Origination Form
Proposed Revisions to a Standard Plans Index

Originator:	Meyer, Ronald	Index Number:	653-001
Date:	6/18/2025	Sheet Number(s):	1 of 1
E-mail:	Ronald.Meyer@dot.state.fl.us	Index Title:	PEDESTRIAN CONTROL SIGNAL INSTALLATION DETAILS

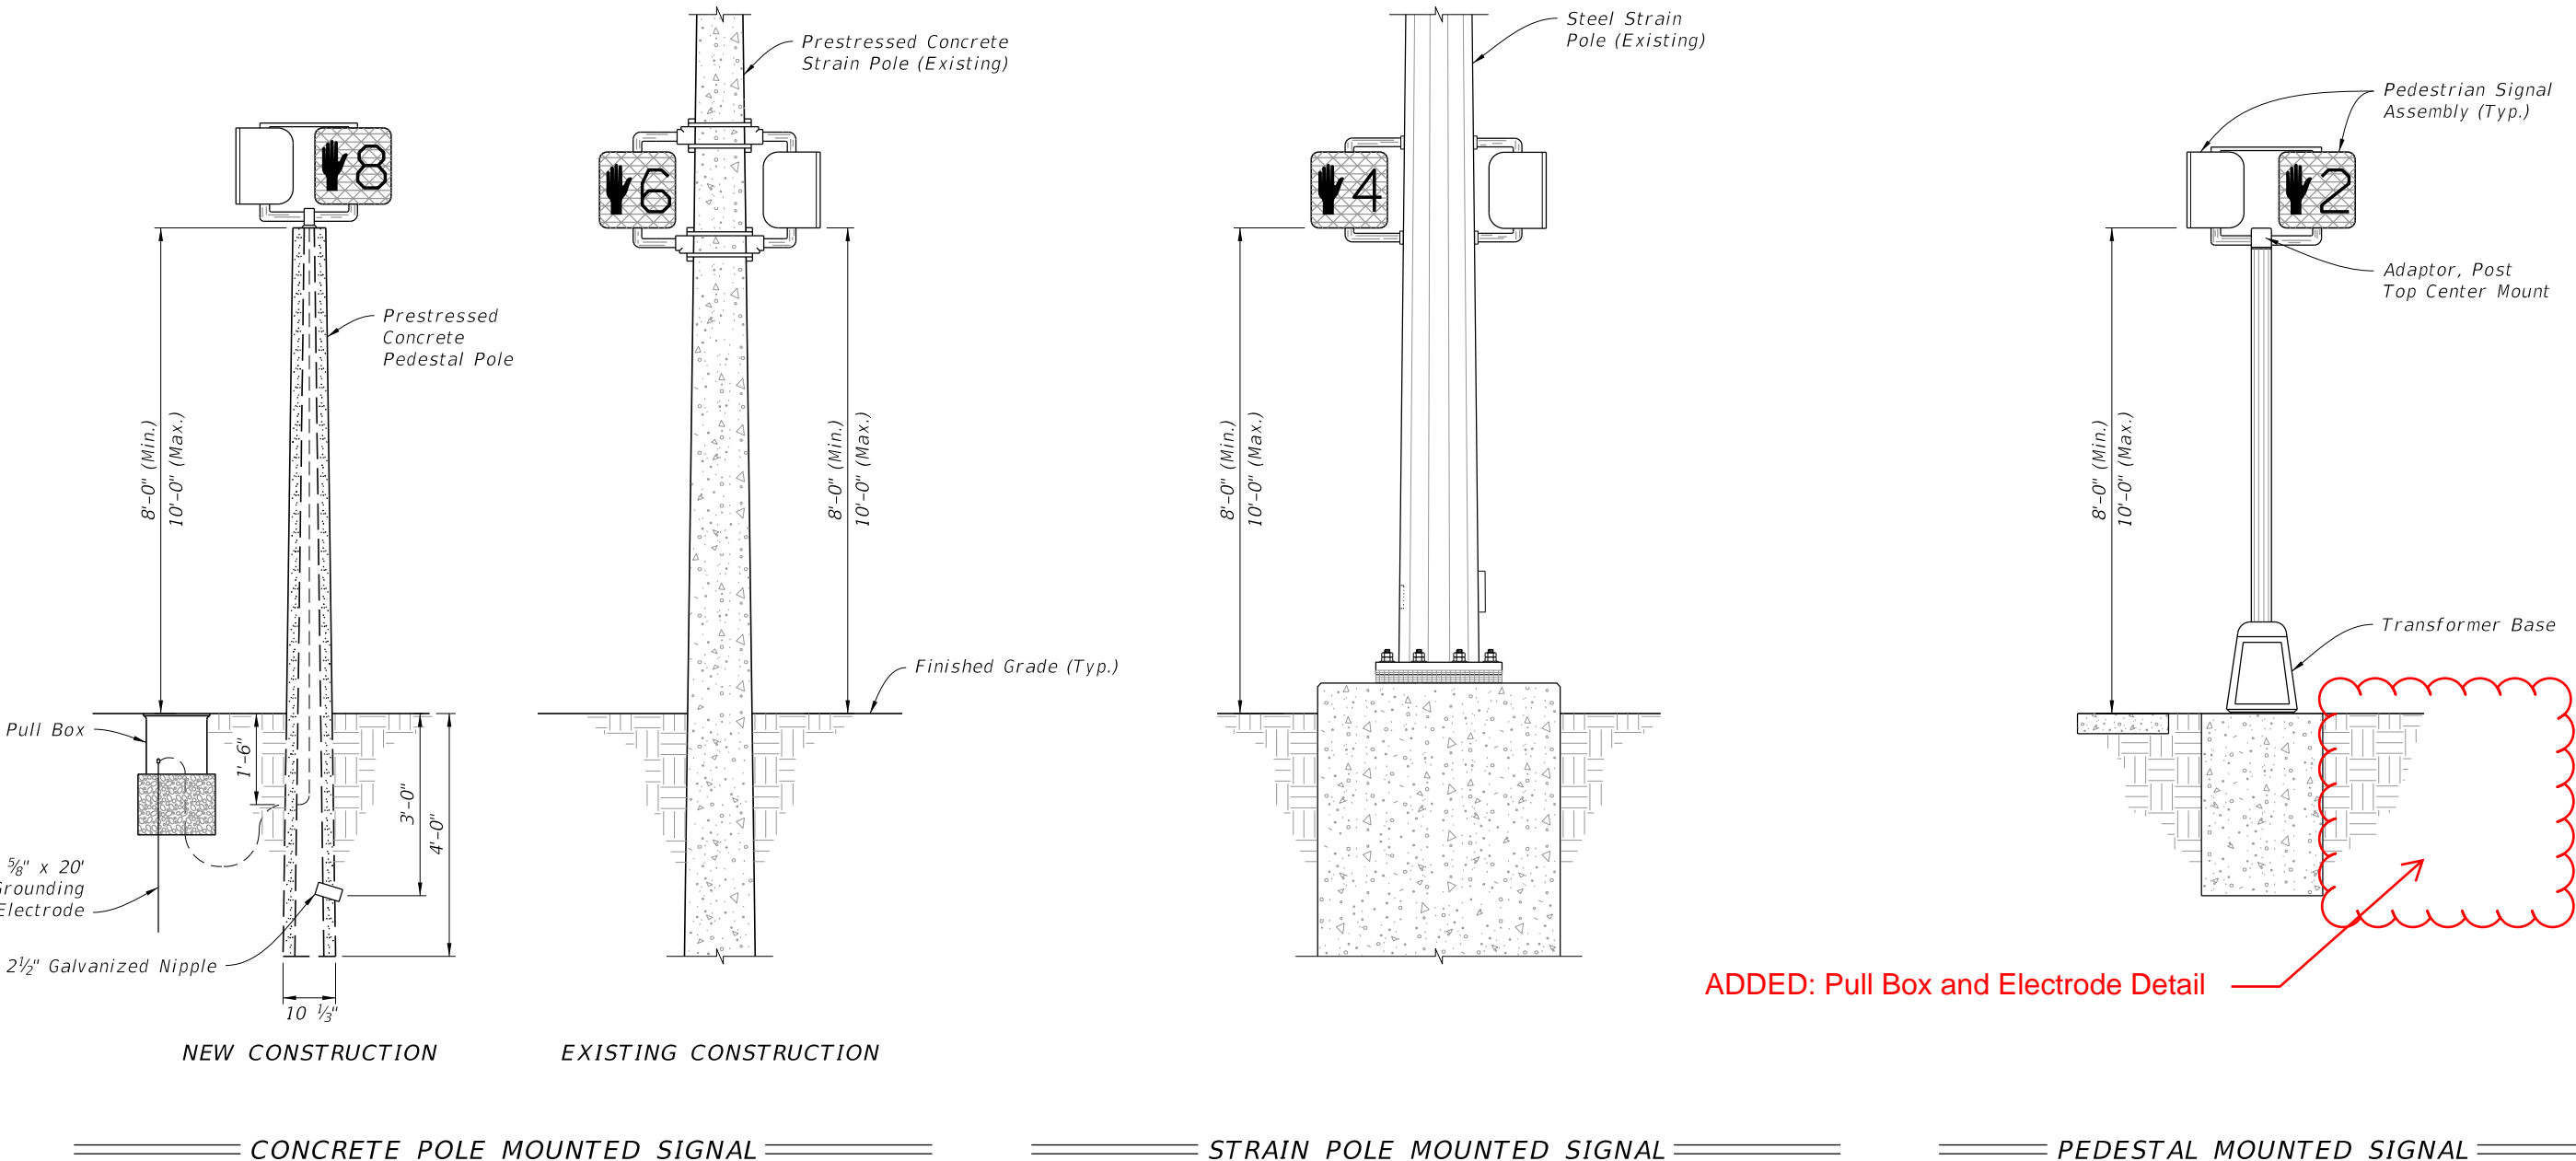
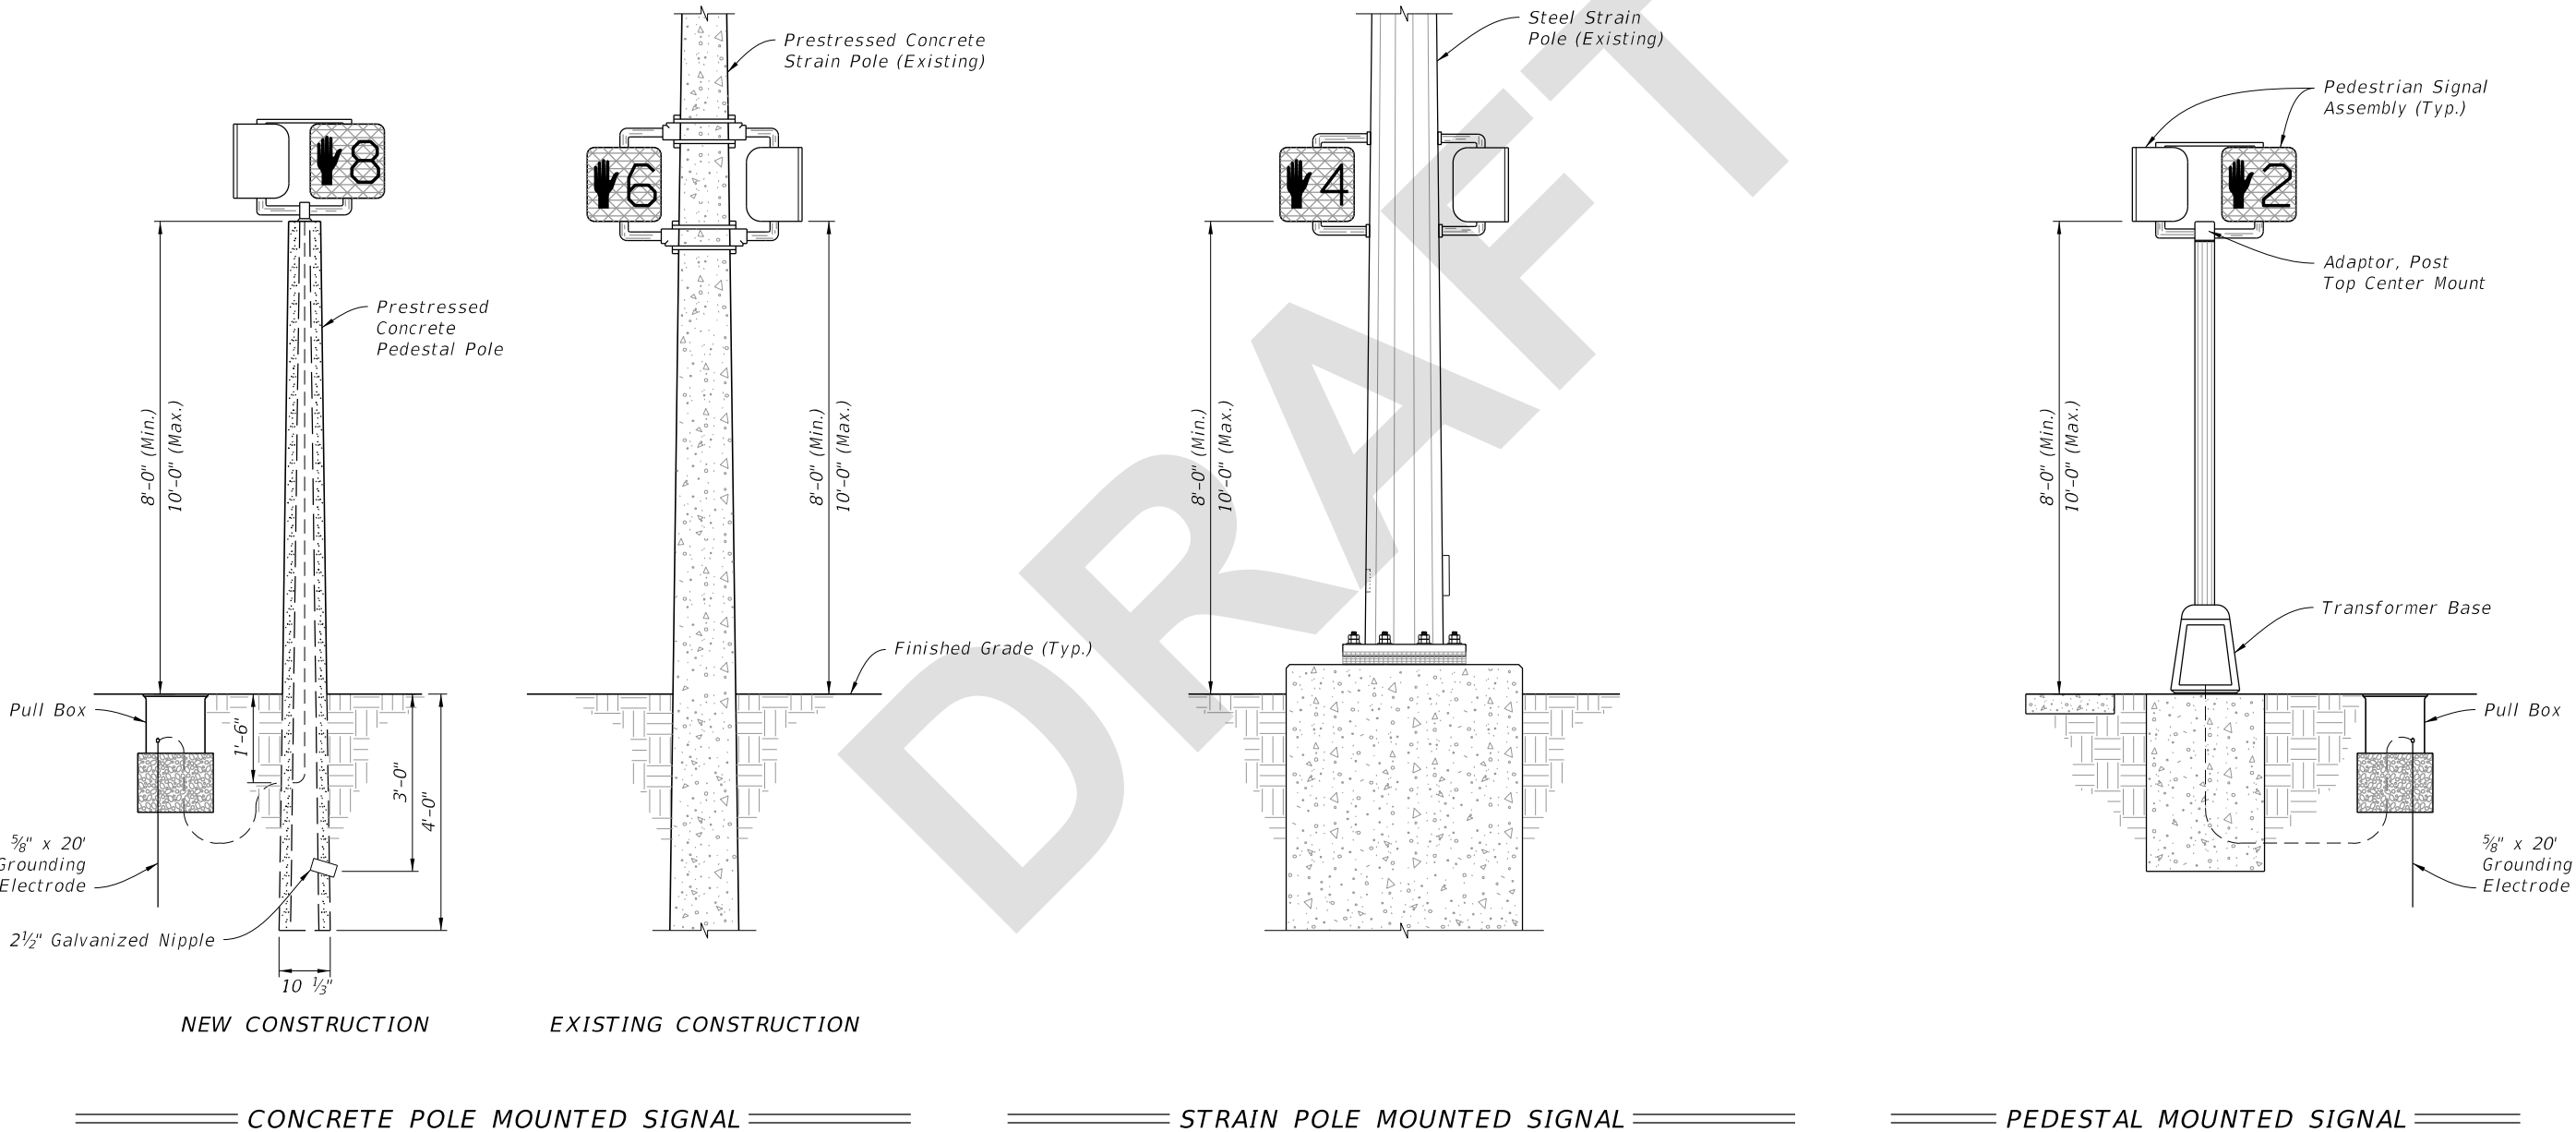
Sheet 1: Added a pull box and grounding rod to the elevation view of the Pedestal Mounted Signal

The TERL has received multiple questions from Contractors regarding clarification of grounding requirements for pedestal poles. This update is to help clarify requirements to reduce future questions. Corresponds with Specification update to 620-3.3.
